From: Owens, Westley E (FAA)
 To: Kercher, Devon S (FAA); Cox, Christopher (FAA)
 Cc: McCloud, Lucas (FAA); Clark, David M (FAA); Hamilton, Robert G (FAA)
 Subject: RE: KSFO-QUIET BRIDGE FORM RECOMMENDATION
 Date: Tuesday, March 31, 2026 3:27:12 PM
 Attachments: image005.png
 image006.png
 image007.png
 image008.png
 image009.png
 image010.png

AIRPORT ID	CVFP NAME	ORIG/AMDT	CITY	STATE	SUPERSEDES	AMDT NO.	DATED	EFFECTIVE DATE
SFO	QUIET BRIDGE VISUAL RWY 28R	A13	SAN FRANCISCO	CA	QUIET BRIDGE VISUAL I	12

Investigation of Possible Revisions to
Simultaneous Parallel Visual Approaches at
San Francisco (KSFO) to Reduce the High
Number of TCAS Resolution Advisories

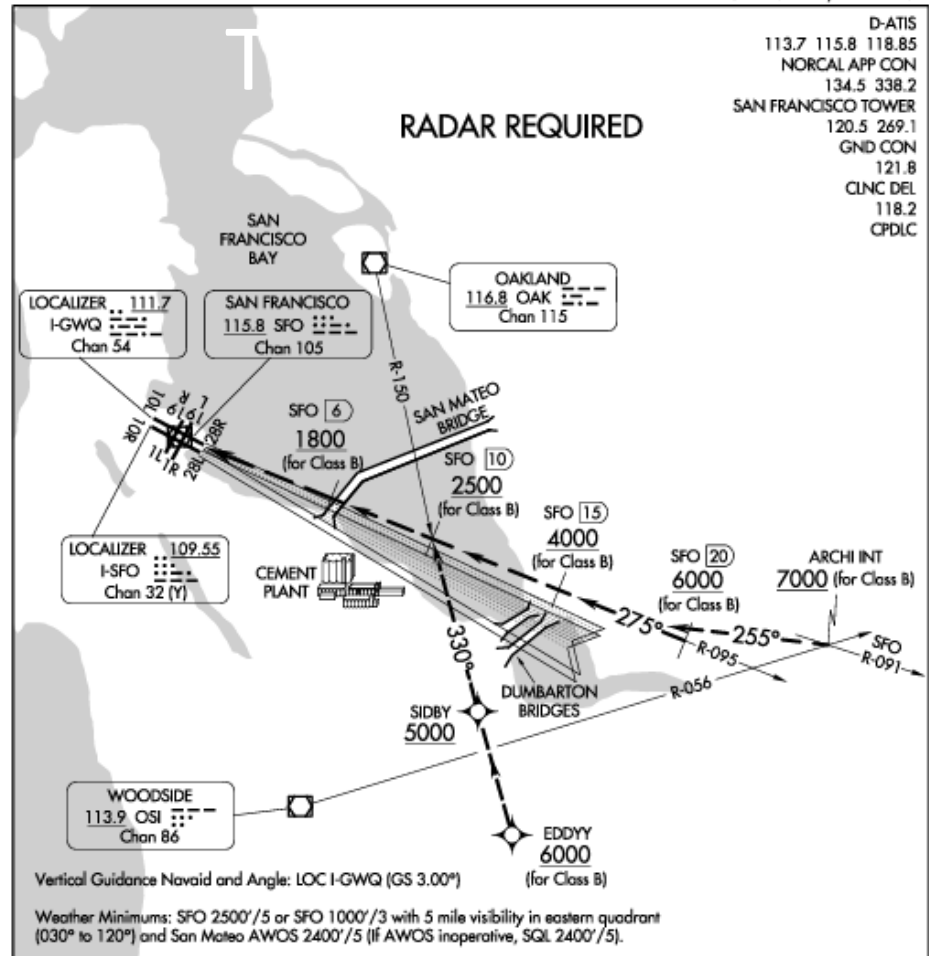
While all of the altitudes within the TO/FROM portion do show that they are for Class B containment, the charted altitudes in the NOTES section are not. According to the regulation you show for altitudes not be established for ATC separation, the altitudes over ARCHI/EDDY.

CHART CROSSING ALTITUDE AT ARCHI; AT 6000 AT EDDY

As this procedure was not developed at the local level, but rather at AFS, ATC wants this portion to go with an approval letter because they did not in fact develop the procedure.

1. WAIVER: 8260.61A 2-1-2 para (f/g) (Waiver to be attached)
2. APPROVAL LETTER: 8260.61A 2-1-2 para (m)(2) (EDDY/SIDBY/ARCHI) Lean into the natural progression of STARS Terminating into the Terminal Environment
3. APPROVAL LETTER: 8260.61A 2-1-1 (Lean in to procedure conceptualized to underlay with the RNAV (GPS) U 28R which will allow inter-operability for ATC)

Of note, RAACL attitude 1800, JANYY 3000 for both procedures. (class B for JANYY)

After speaking with management, we do not think that the approval letters are necessary. The references from the 8260.61A do not reflect items that require approval for the QUIET BRIDGE VISUAL RWY 28R.

We do not require an approval letter as on the most current version of the 8260-40 we are working on has "(FOR CLASS B)" next to the altitudes. This is within criteria as per 8260.61A 2-1-2 (m)(3):

- (3) Where necessary, minimum altitudes to contain an aircraft above the floor of Class B airspace must be established and annotated "for Class B."

There is nothing specific that I can see from this section that would indicate our procedure needing an approval letter.

RNAV (GPS) U 28R

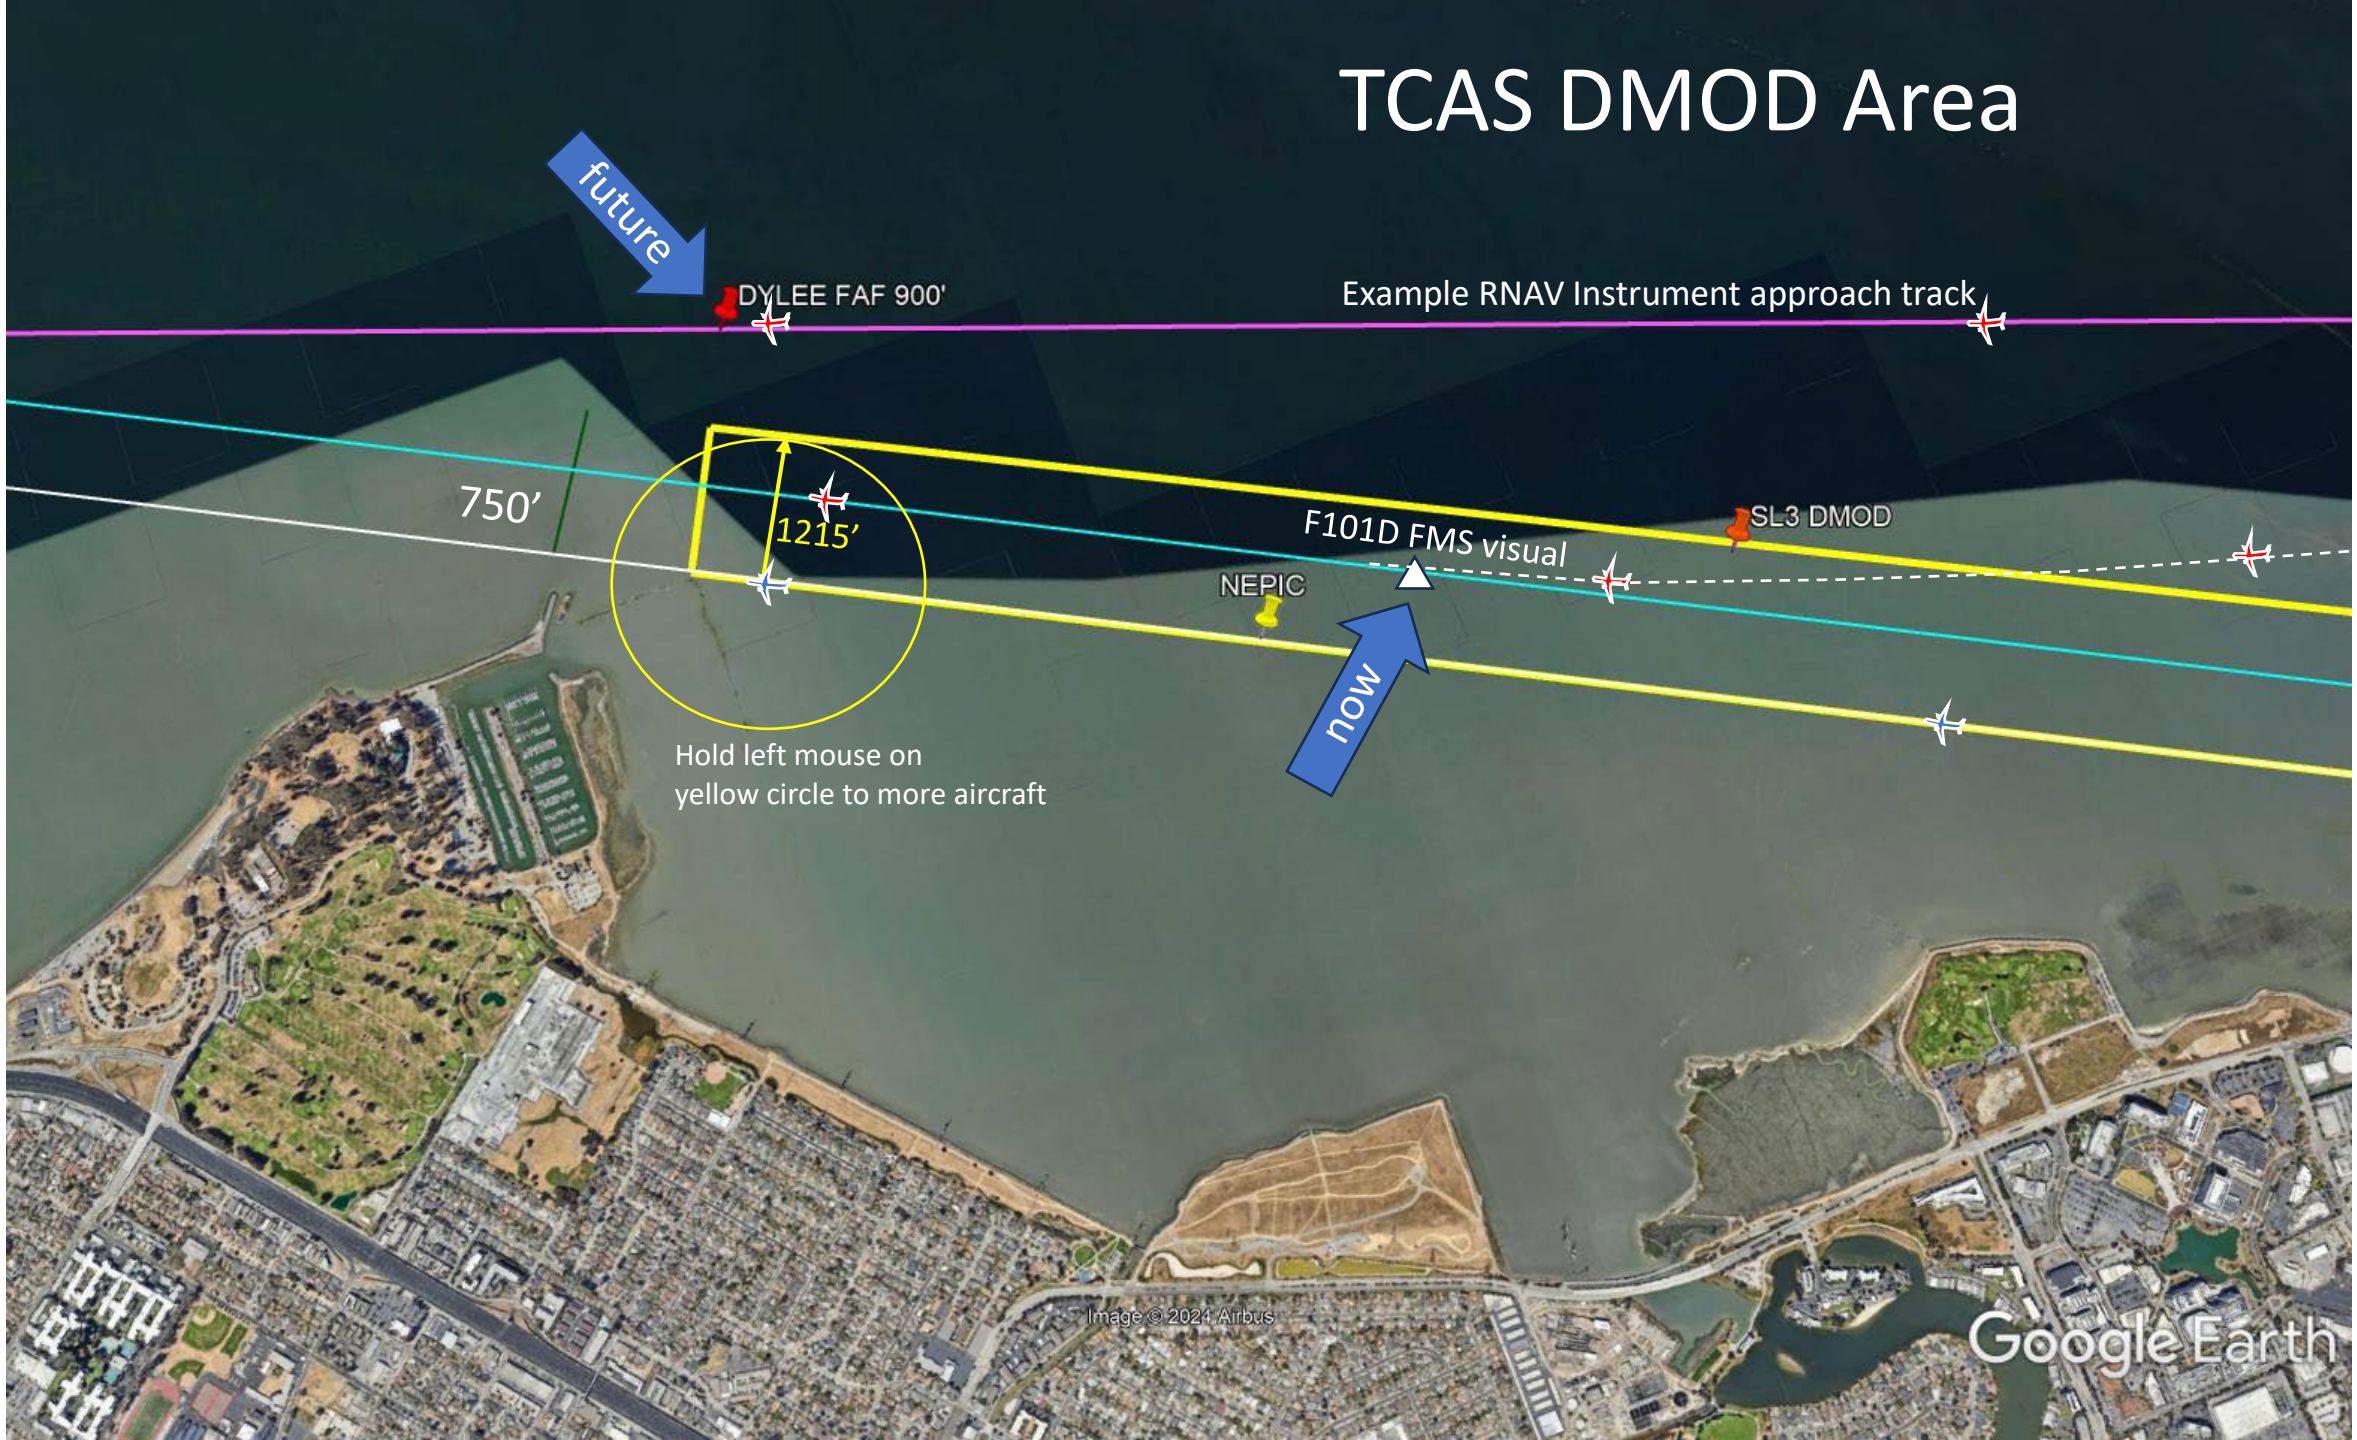
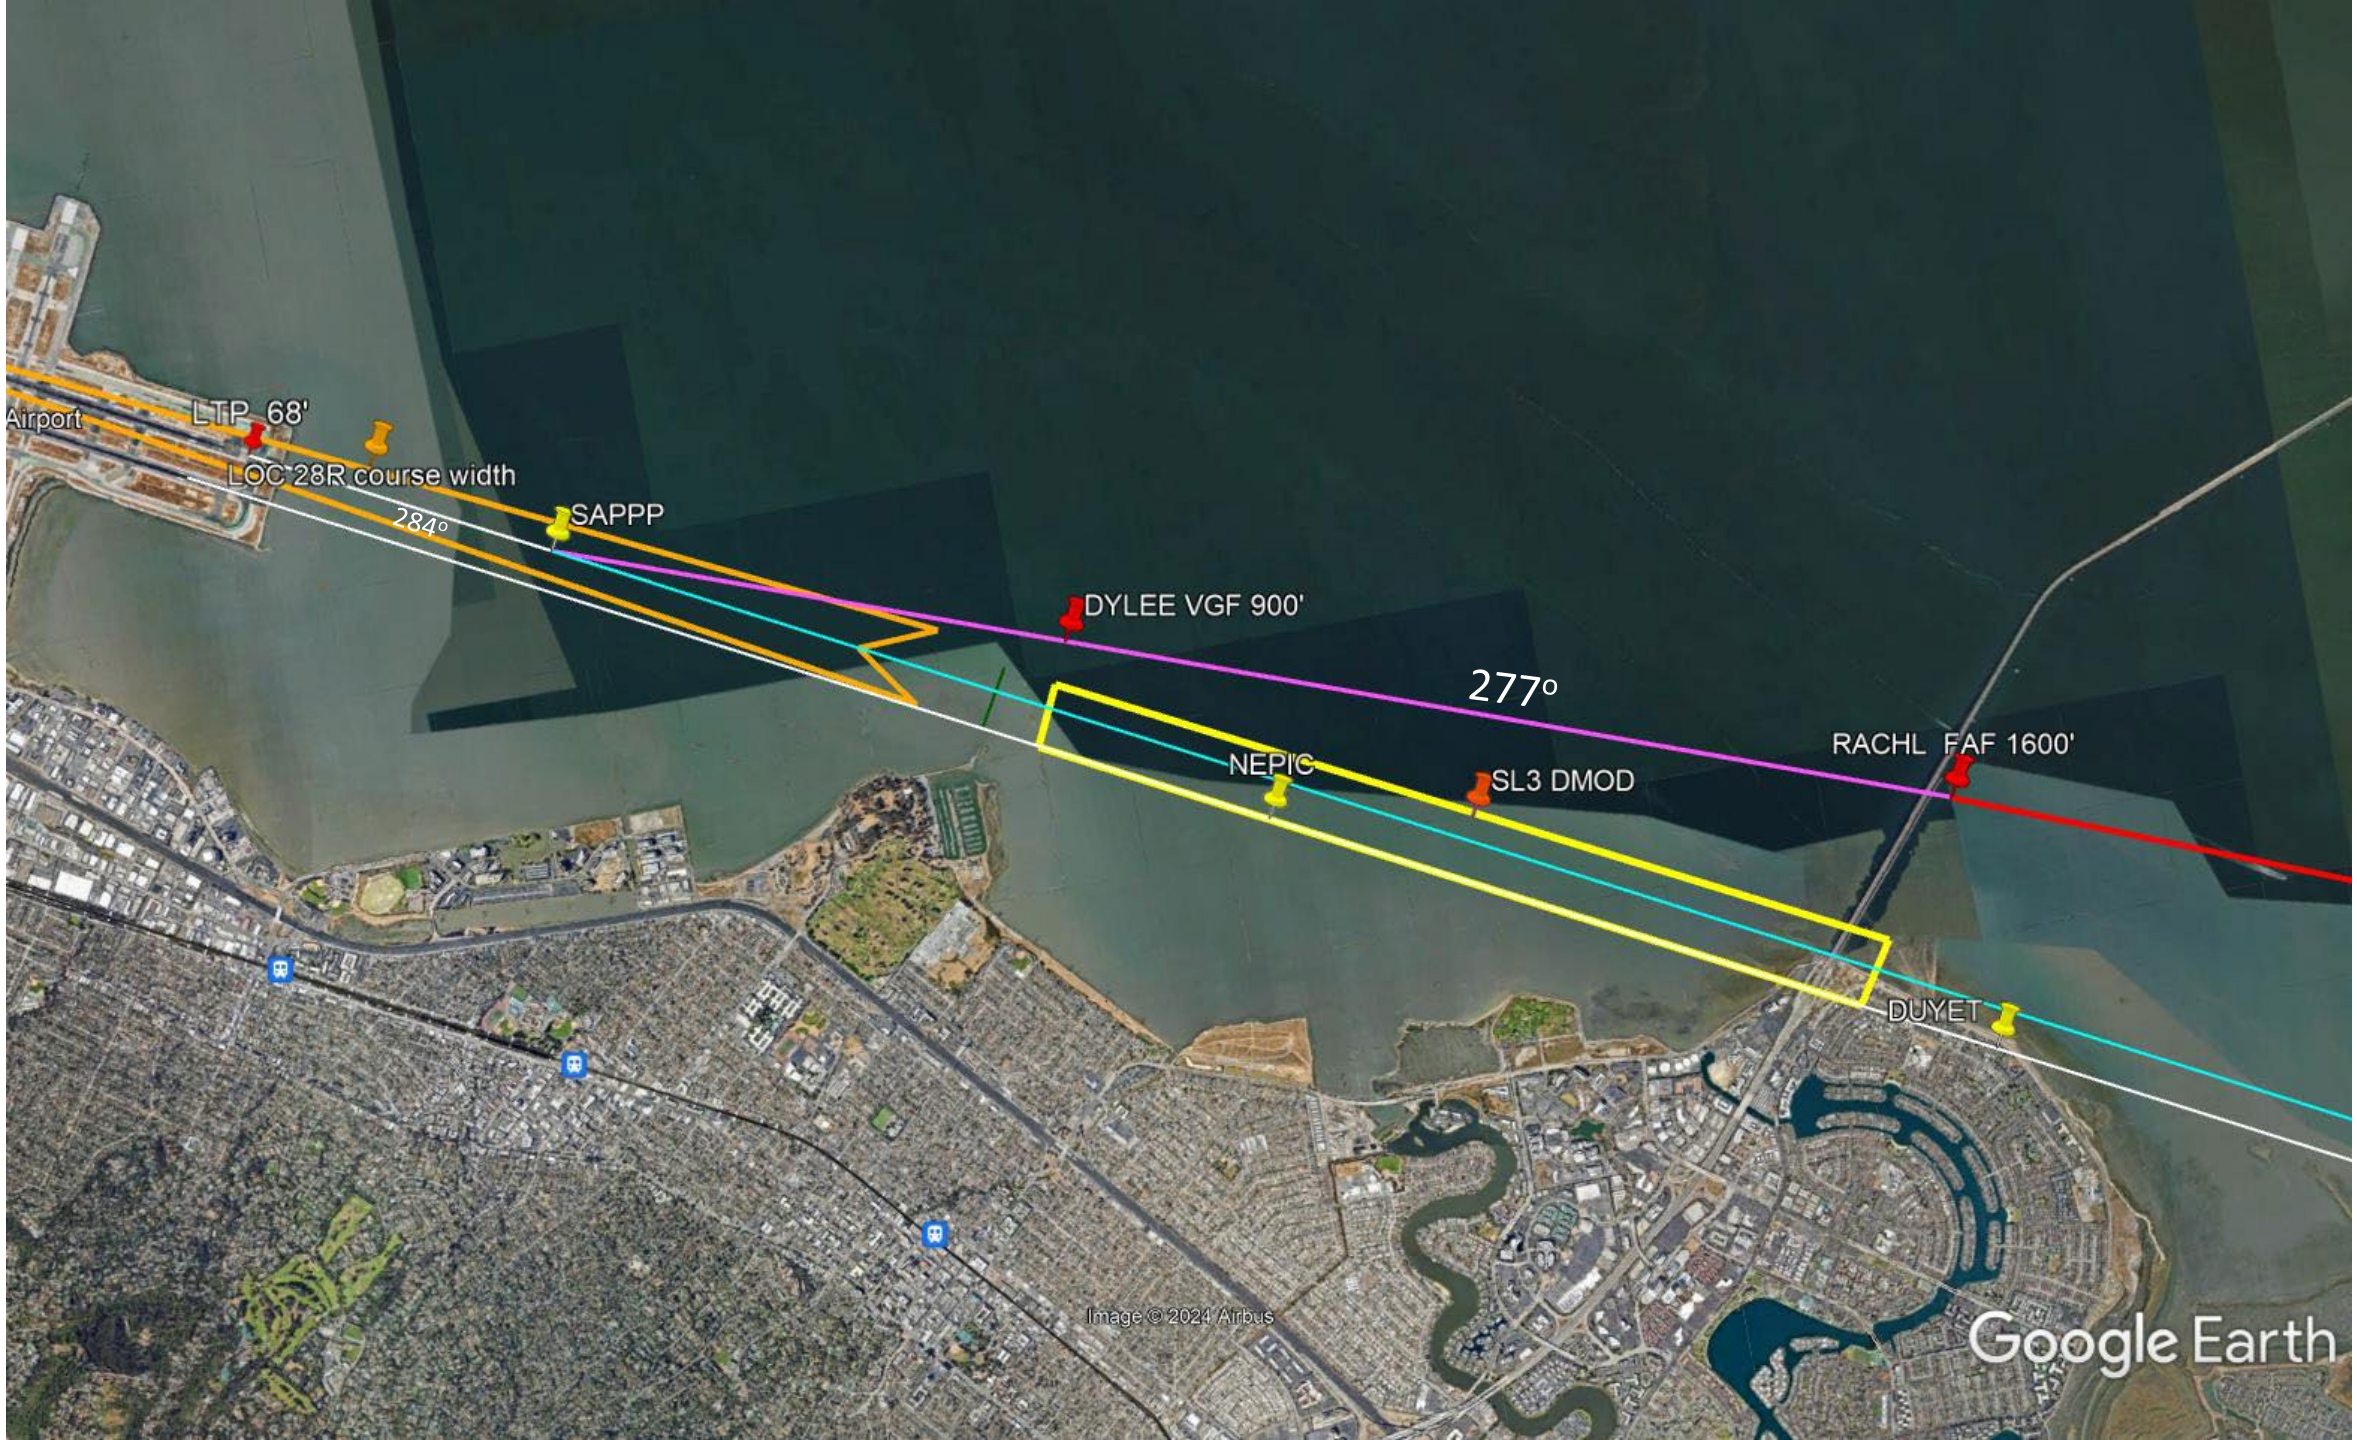
- Design a flyable 28R RNAV instrument approach whose track guidance, when followed, will keep the aircraft landing 28R and 28L latterly separated so as to remain outside of TCAS SL3. (Below 1000 feet AGL, TCAS RA's are not issued.)
- Waypoints of the proposed RNAV instrument approaches will be initially published on the FMS visual (or an RNAV visual) until the RNAV instrument approaches can be developed and published by the FAA. At that time, the waypoints will be added to the Quiet Bridge Visual approach, and the FMS or RNAV visual will then no longer be required.
